50% Conceptual Design Review

33 kT Liquid Argon Detector Excavation

33 kT LAr Changes for 90%

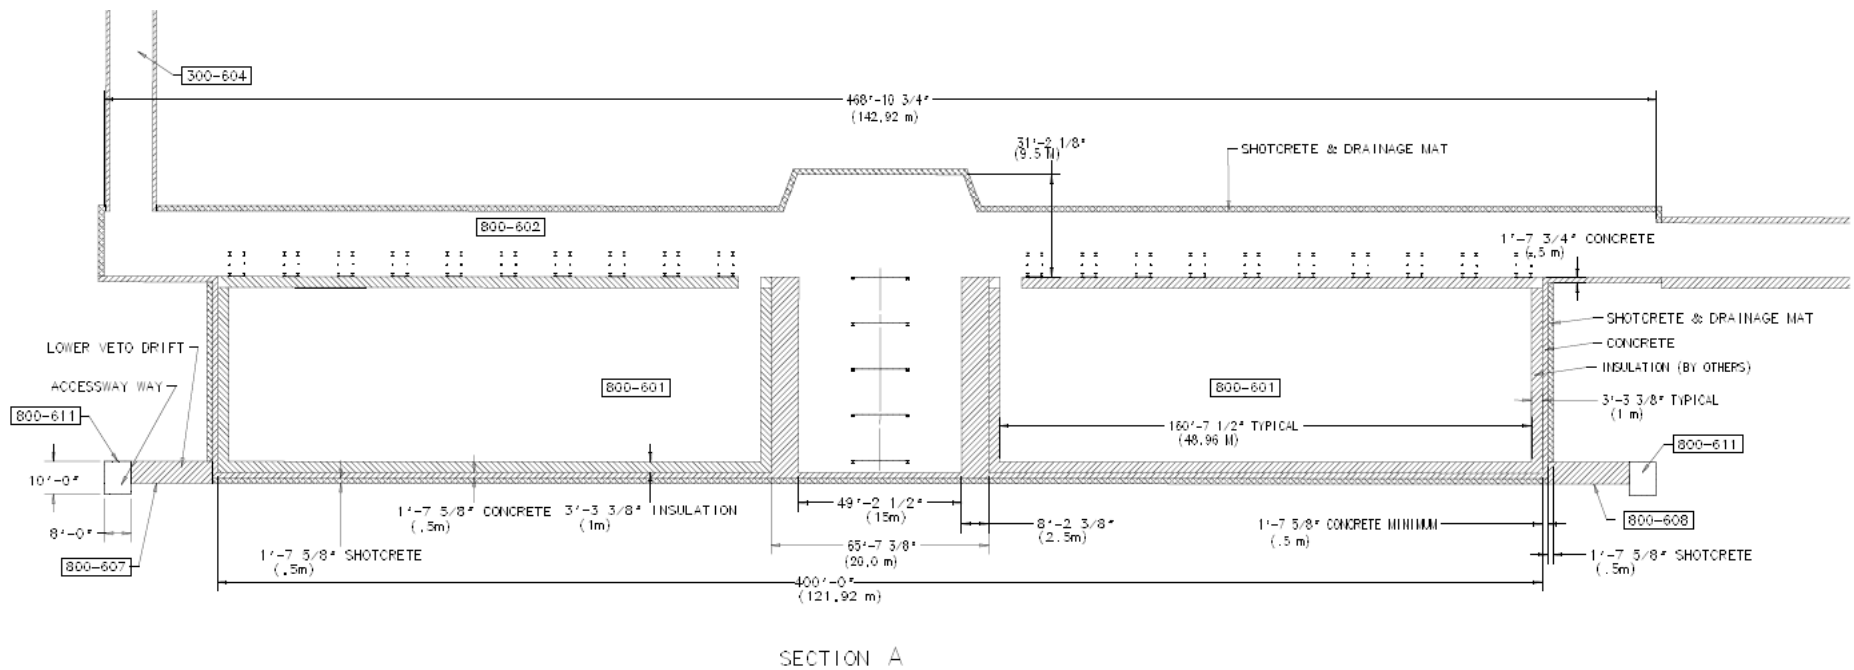
- Extend length of cavern to accommodate 20 meter septum

33 kT LAr Changes for 90%

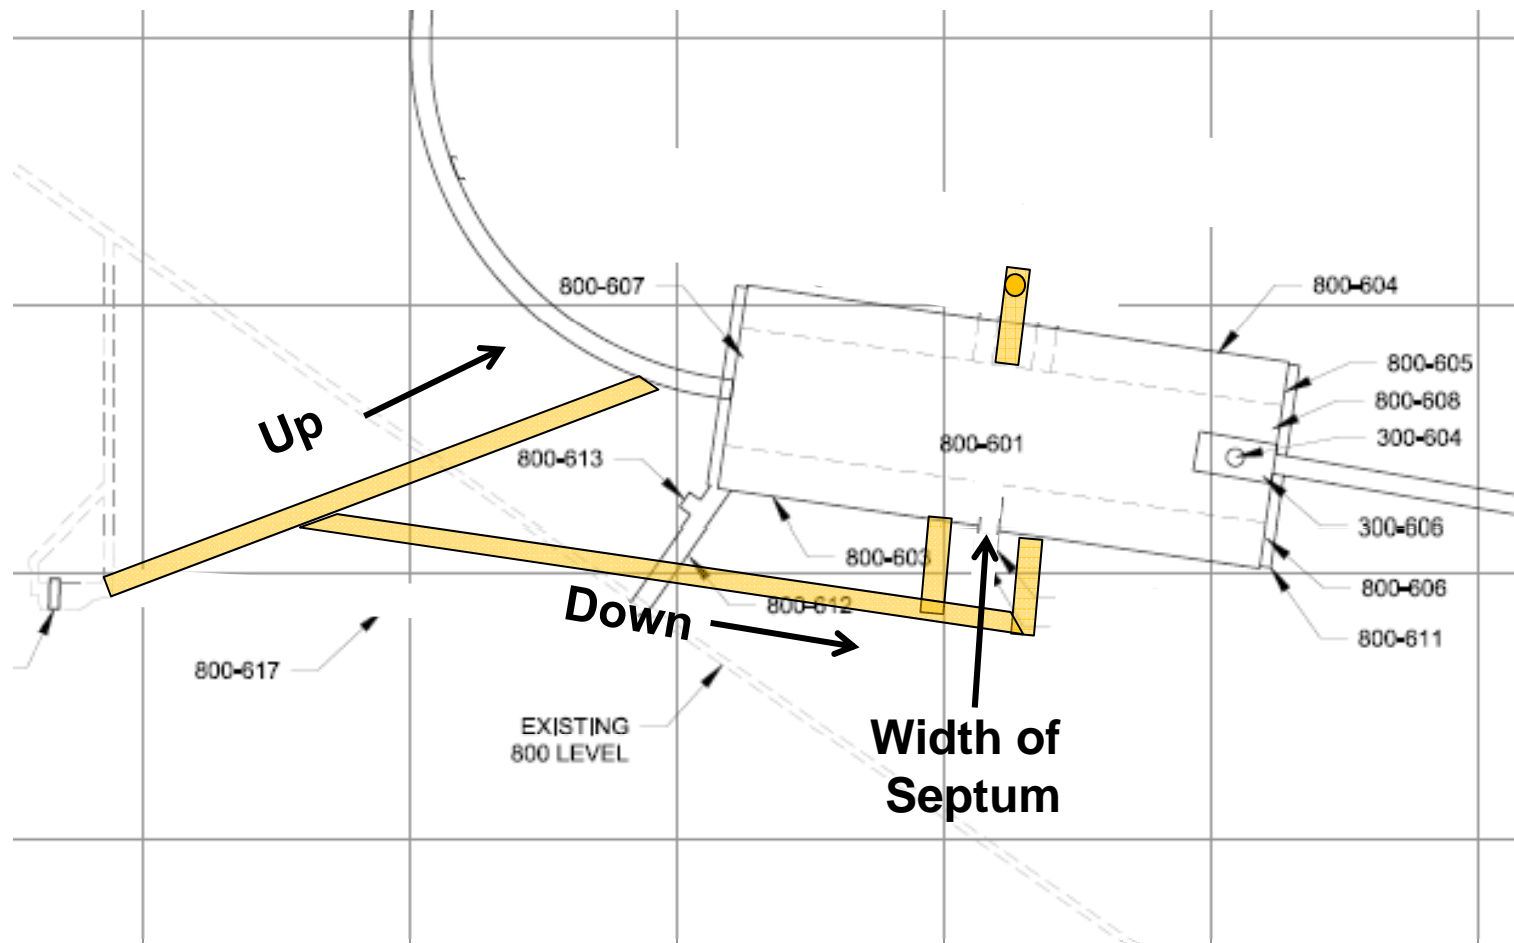
- Realign Ross Access and reduce grade on lower ramp to 15%

33 kT LAr Changes for 90%

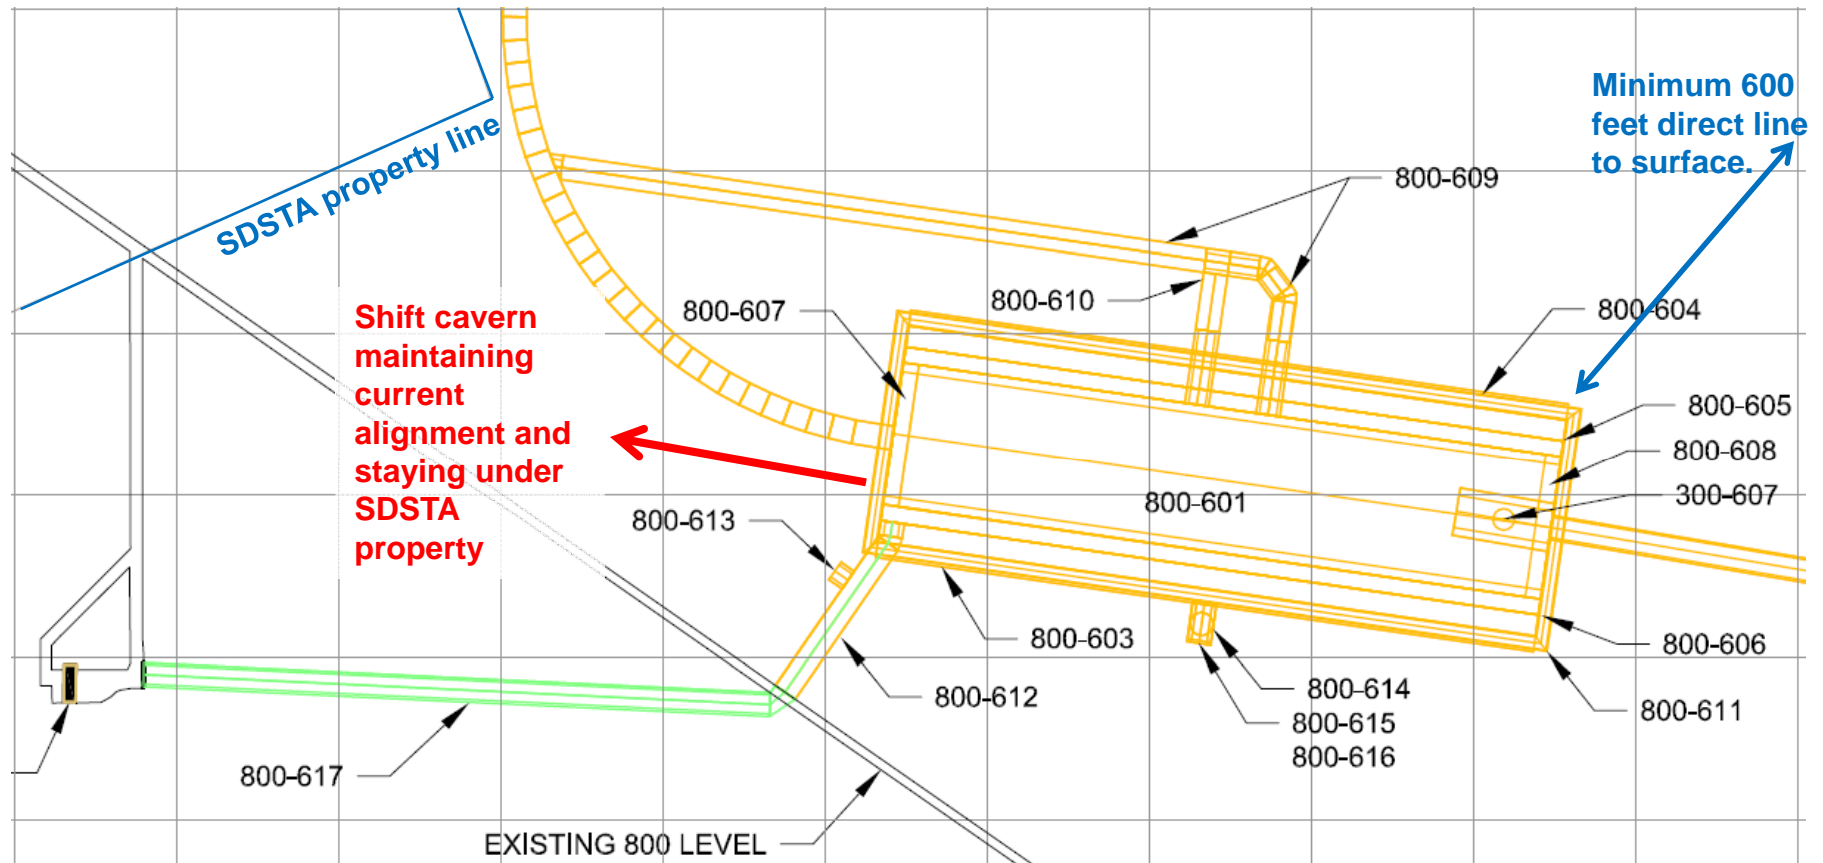
- Confirm 600 feet minimum (690 ft average vertical) rock cover with new surface topo and move cavern west (deeper) if needed.

Changes for 90%

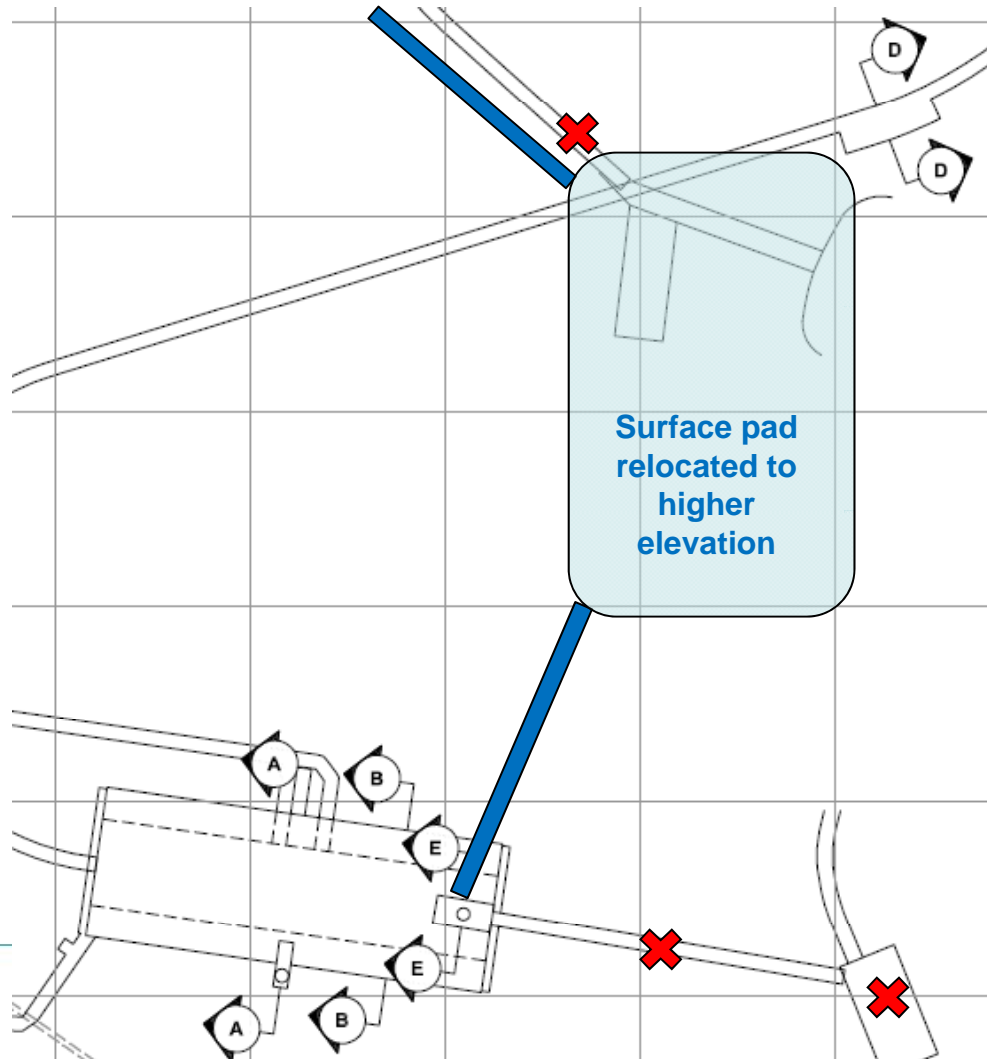
- Relocate portals to match relocation of surface facilities

33 kT LAr Changes for 90%

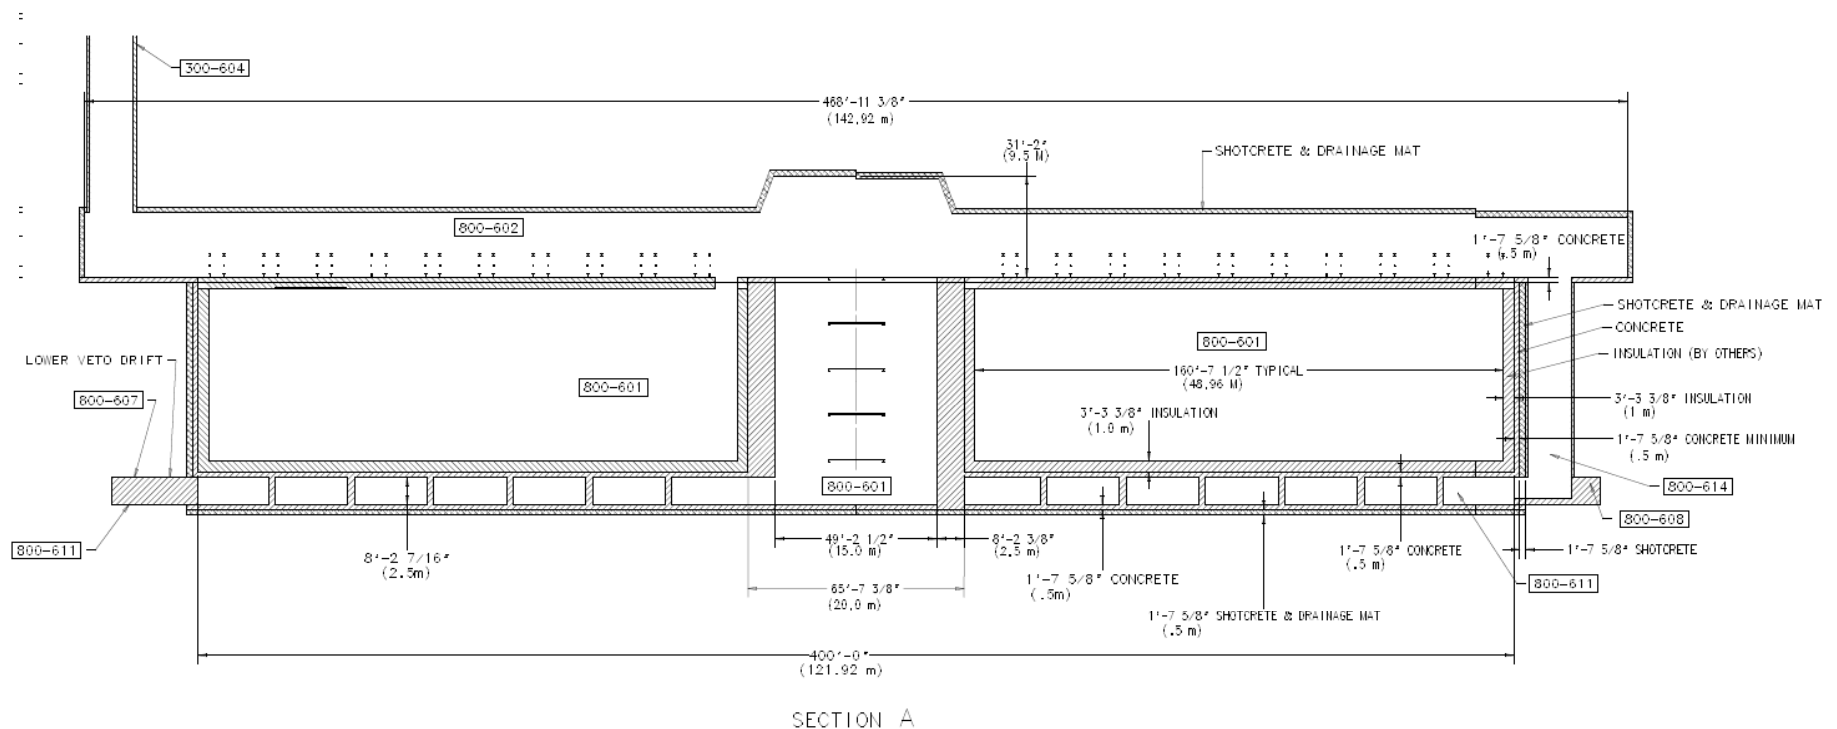
- No change to design for veto tube access but add qualitative discussion of “basement” alternative.
